Applicants: Alex MATUSEVICH Conf: 1477
Application No.: 09/156,761 Group: 2663
Filed: September 18, 1998 Examiner: Jasper C. KWOH
For: TDMA COMMUNICATION SYSTEM AND METHOD INCLUDING
DISCONTINUOUS MODULATION FOR REDUCING ADJACENT AND
CO-CHANNEL INTERFERENCE

DRAWING CORRECTION APPROVAL REQUEST

FIG. 1 (Prior Art)

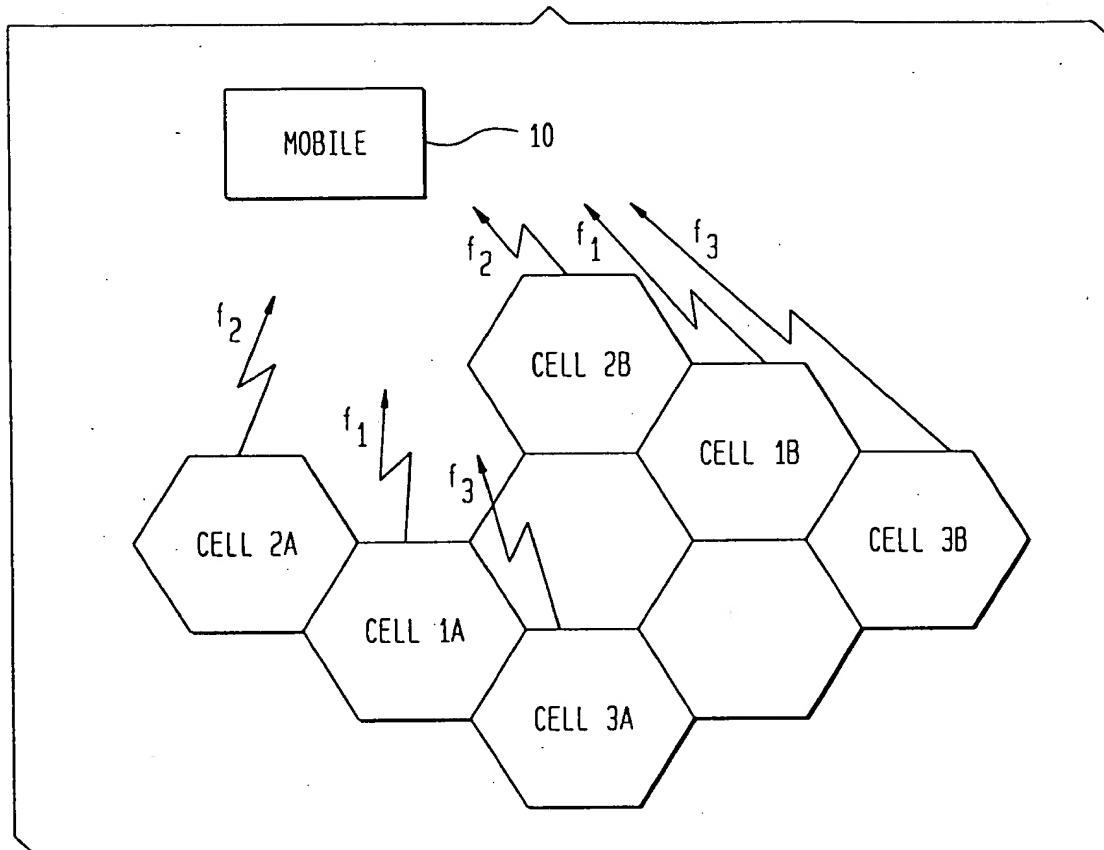
Figures 1-3 have been designated by a legend of --Prior Art--.
